ADDENDUM NO. 02

COLTON MIDDLE SCHOOL – INTERIM HOUSING

DSA #04-124403

RCA Project No. 1-15-118

ENLARGED SITE PLAN AT
PARKING LOT MOD

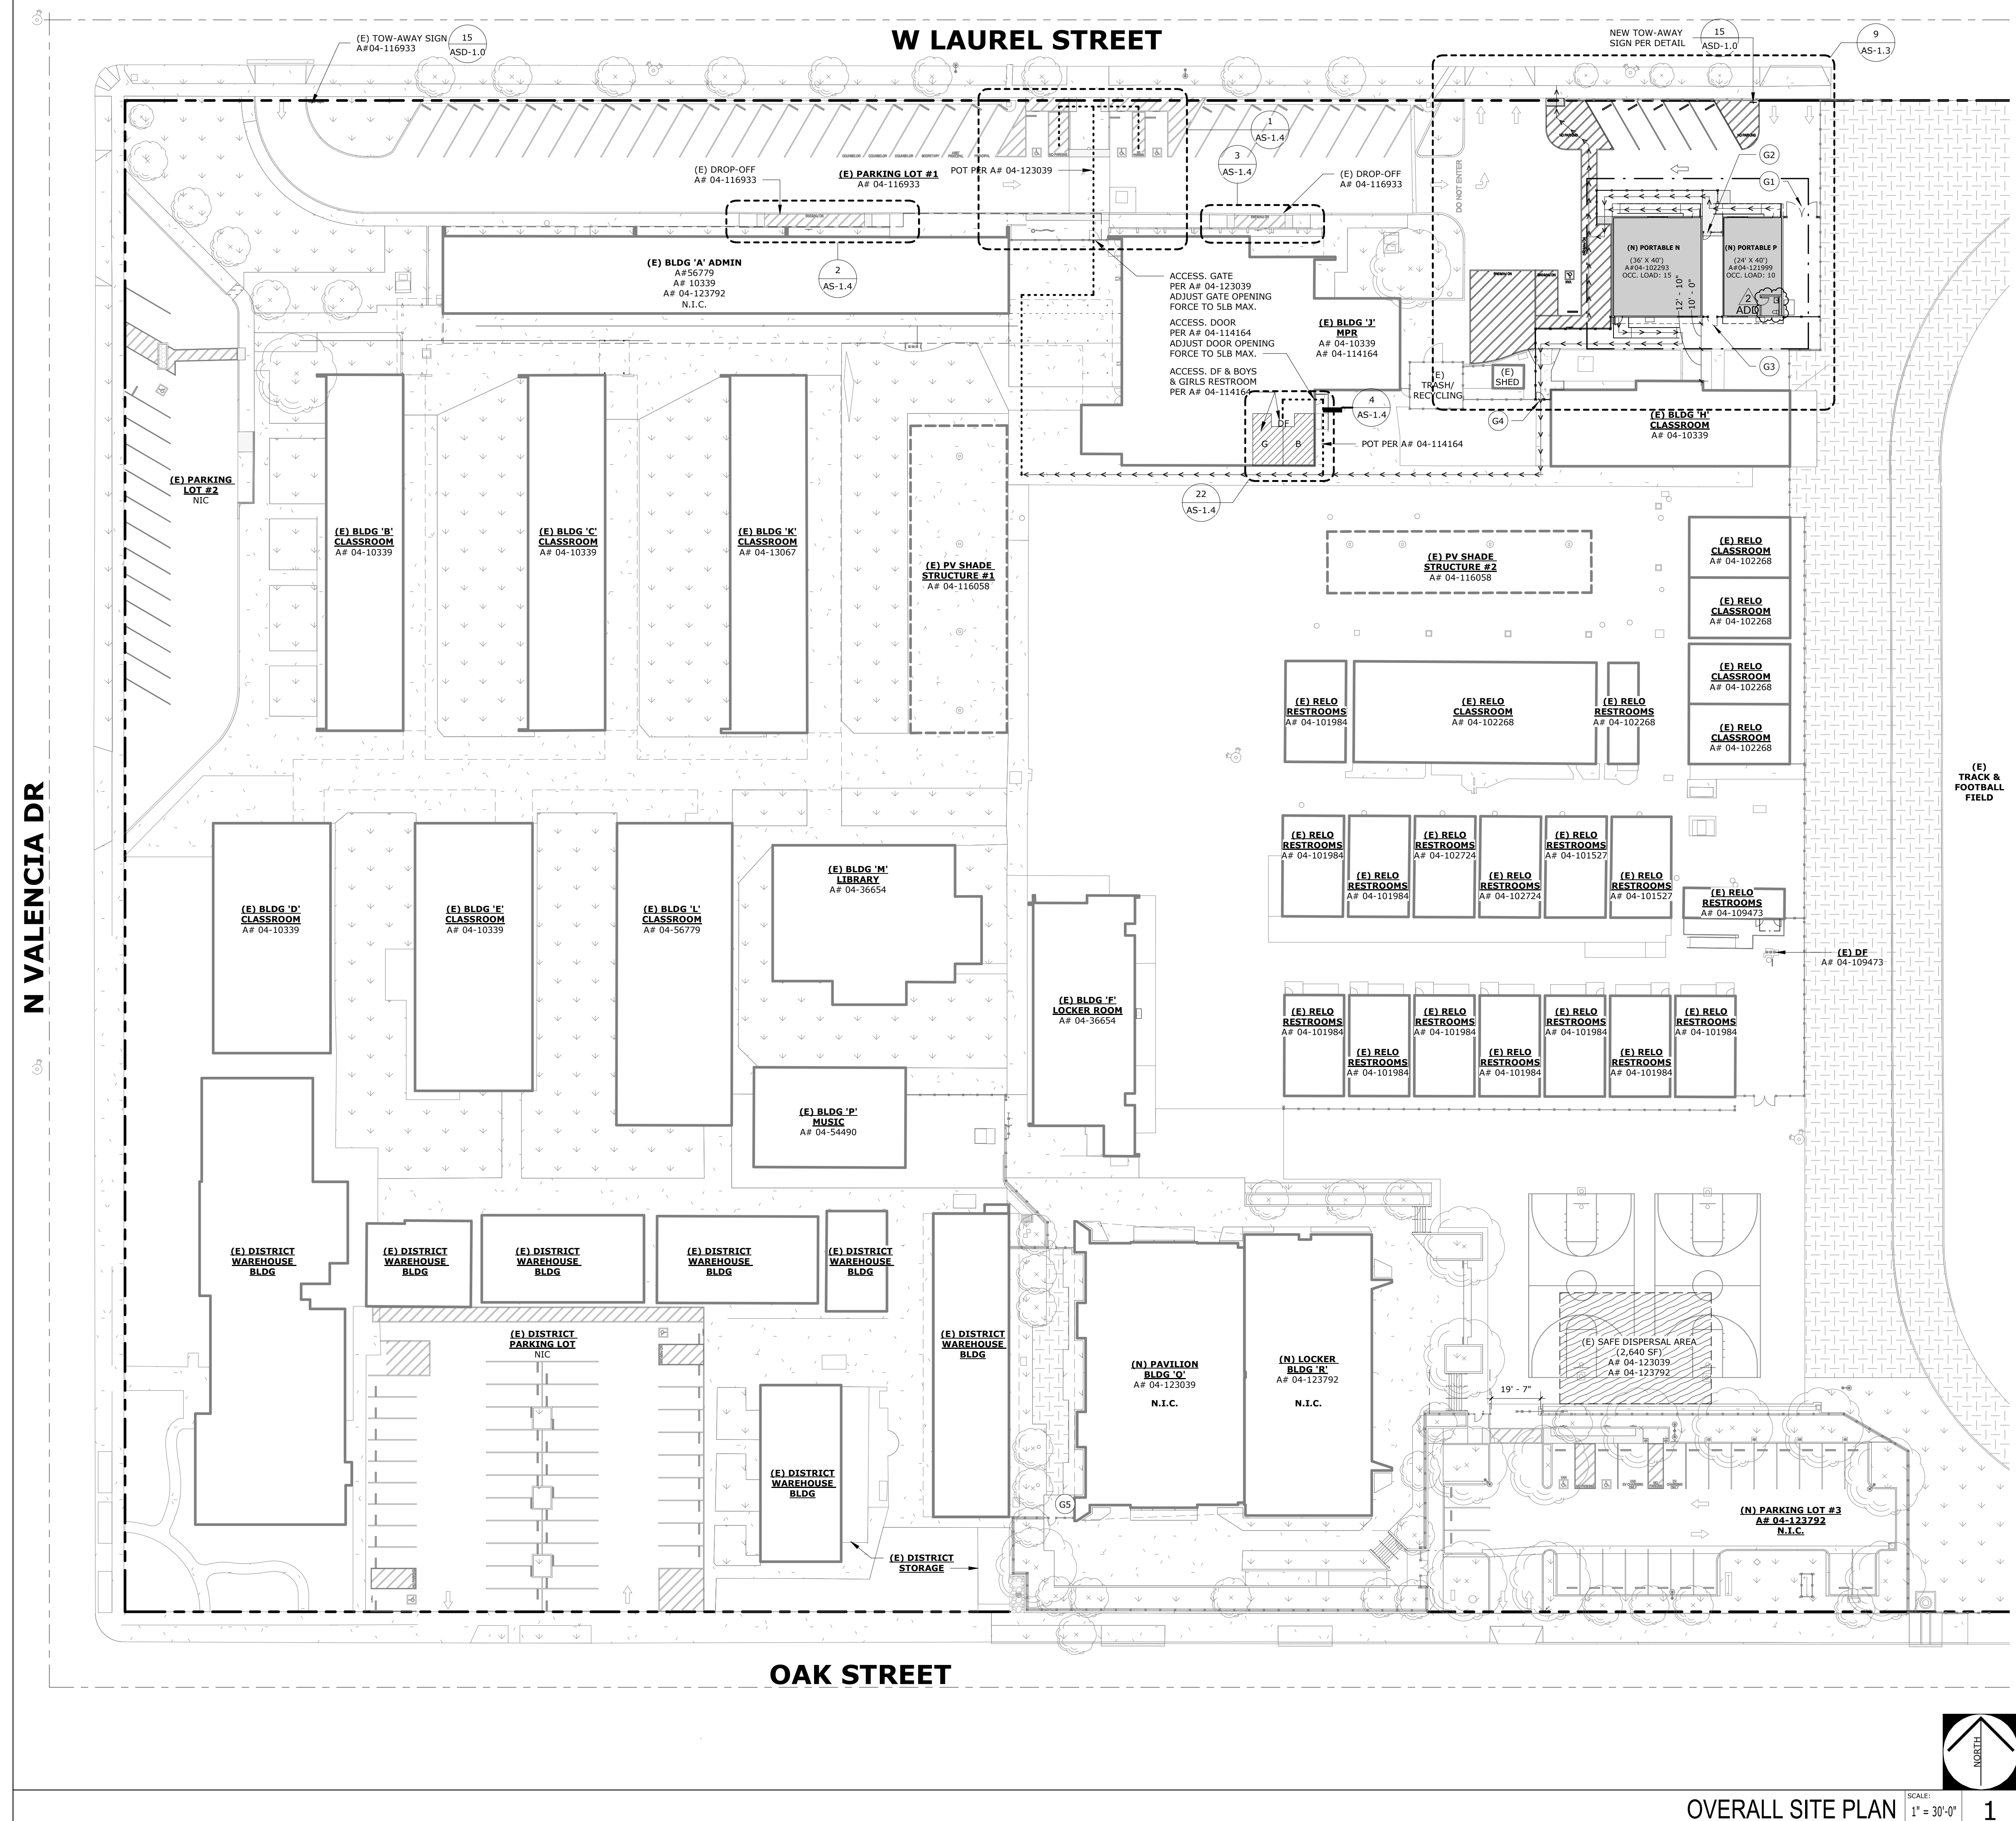
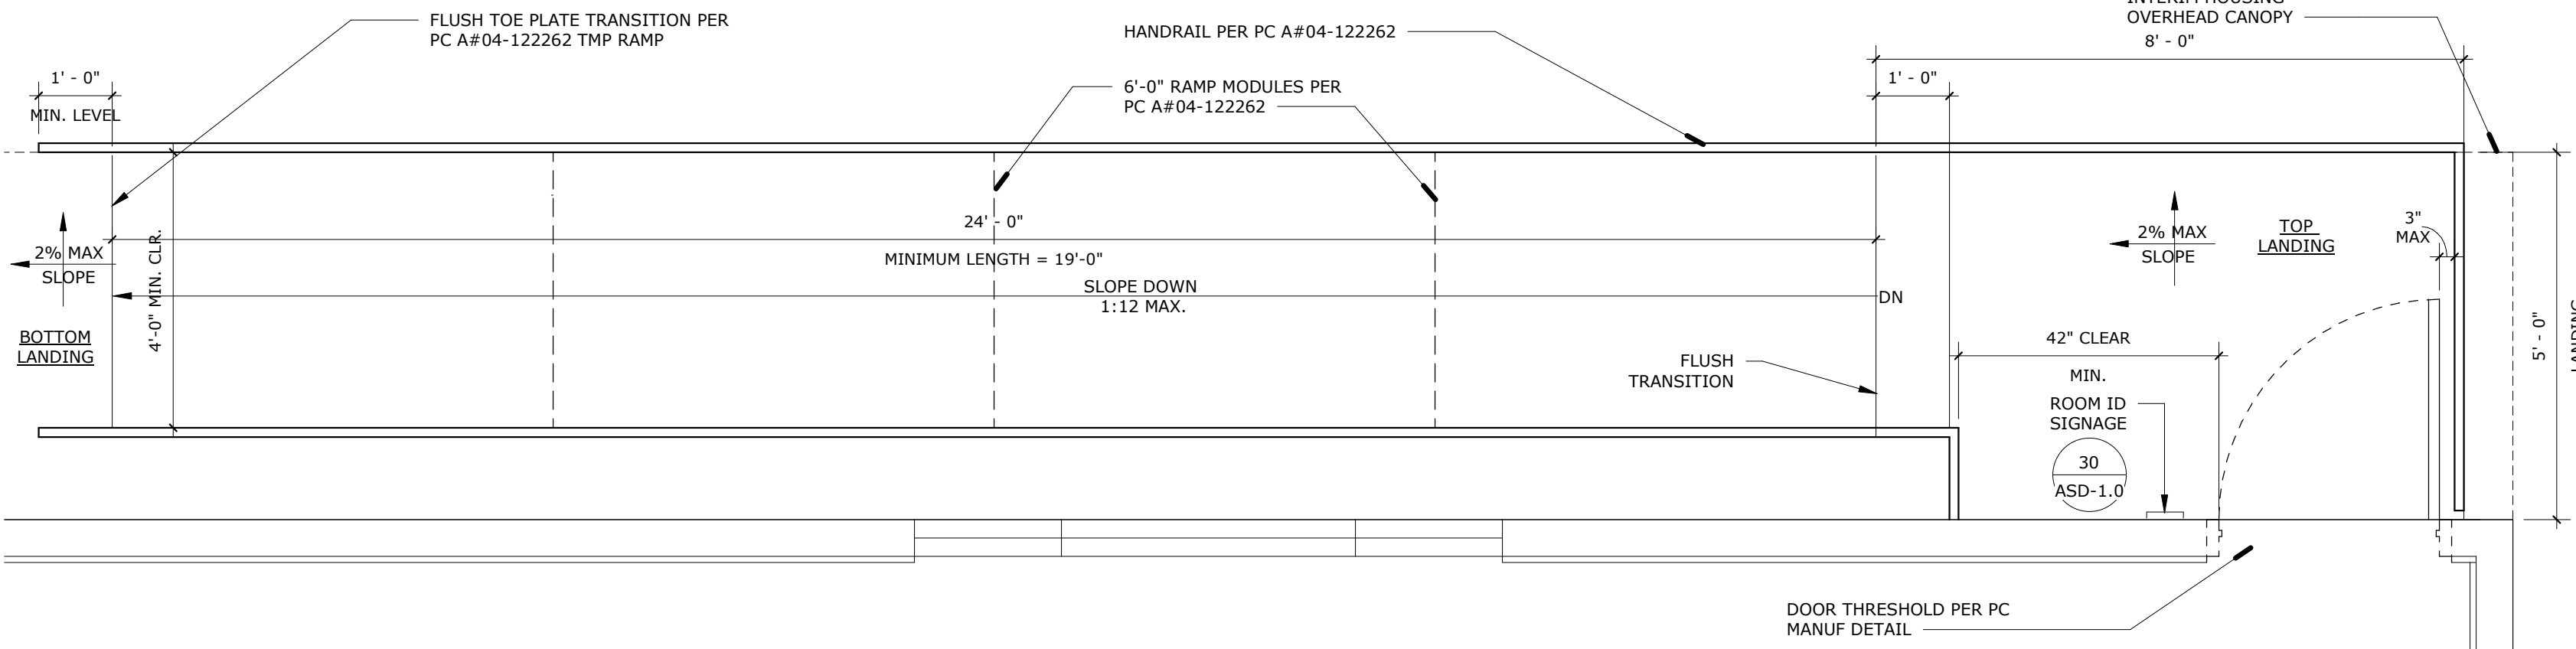
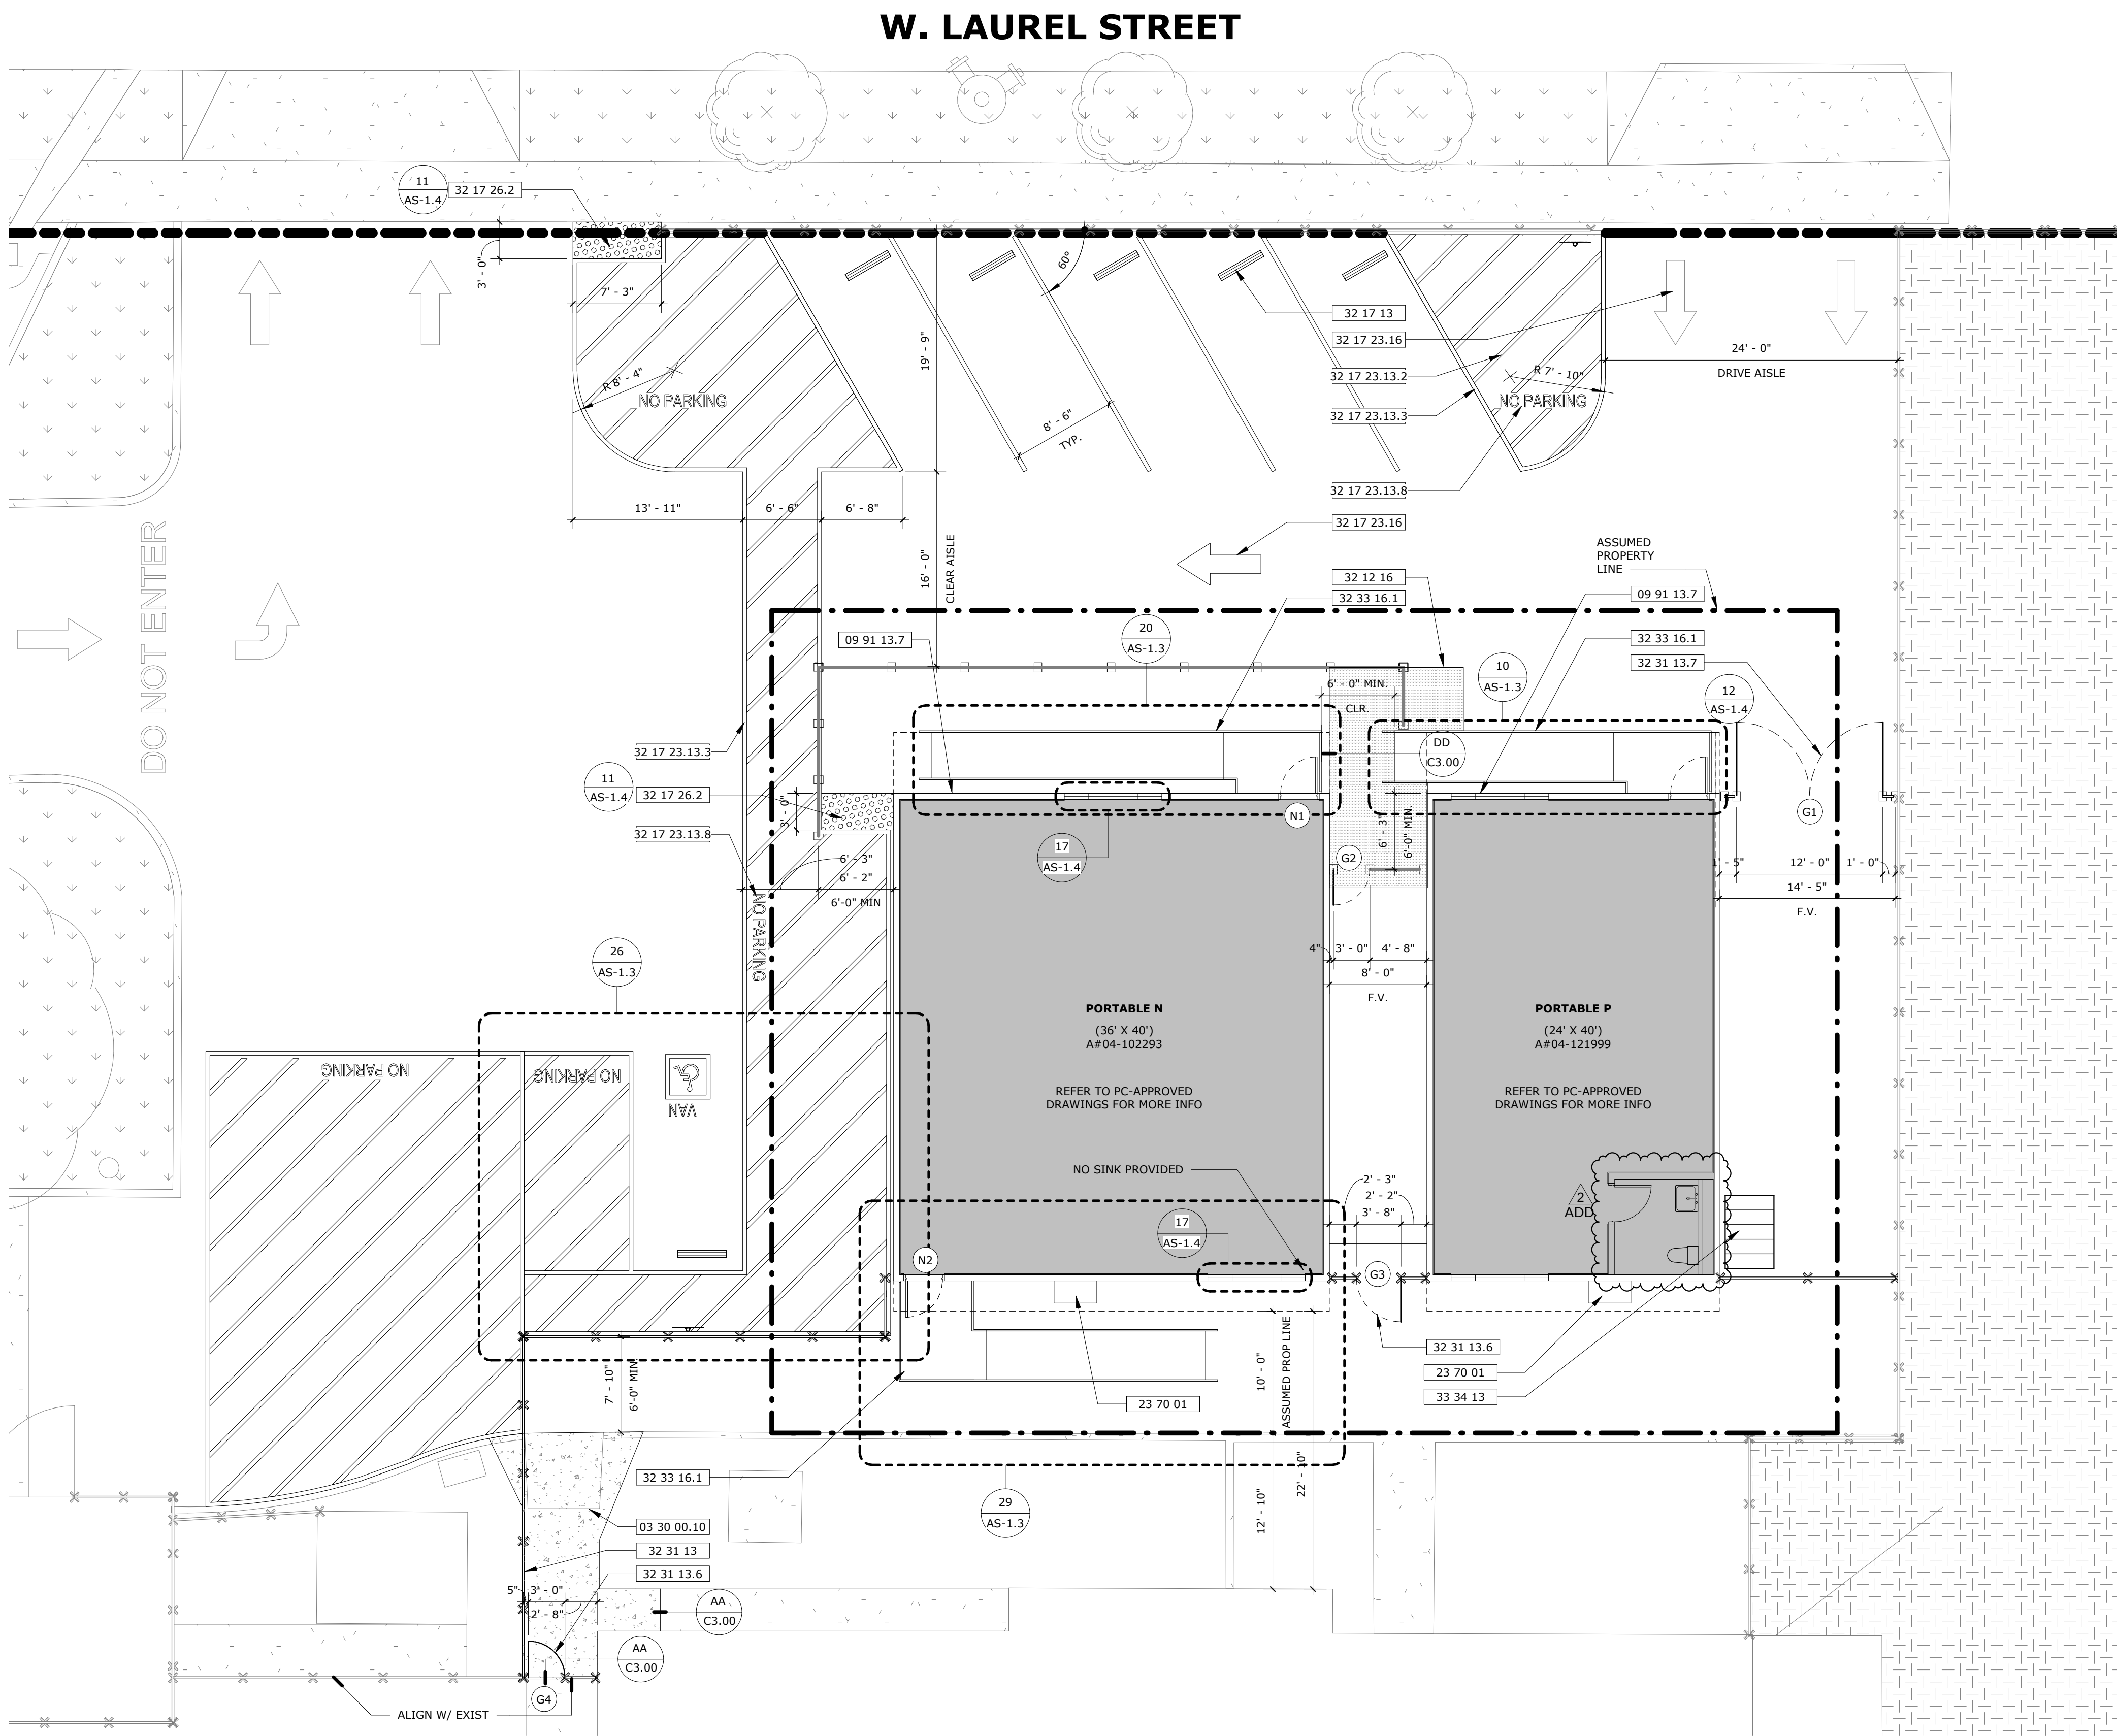
- Item No 2.1 Reference Sheet G-1 – Title Sheet & Sheet Index
 - 2.1.1 Removed sheet F3.01 and F3.11 from to Modtech drawings
 - 2.1.2 Added sheets F1.02 and F1.21 from Modtech drawings
 - 2.1.3 Revised Scope of Work narrative to show portable units N and P as OFOI.
- Item No 2.2 Reference Sheet AS-1.0 – Fire Access Site Plan
 - 2.2.1 Revised restroom at Portable P to match Silvercreek Modular drawings
- Item No 2.3 Reference Sheet AS-1.1 – Overall Site Plan & Code Analysis
 - 2.3.1 Revised restroom at Portable P to match Silvercreek Modular drawings
- Item No 2.4 Reference Sheet AS-1.3 – Enlarged Site Plan at Parking Lot Mod
 - 2.4.1 Revised restroom at Portable P to match Silvercreek Modular drawings
 - 2.4.2 Revised keynote 32.33.16.1 ramp to OFOI
- Item No. 2.5 Reference Sheet E-0.2 – Electrical Schedules
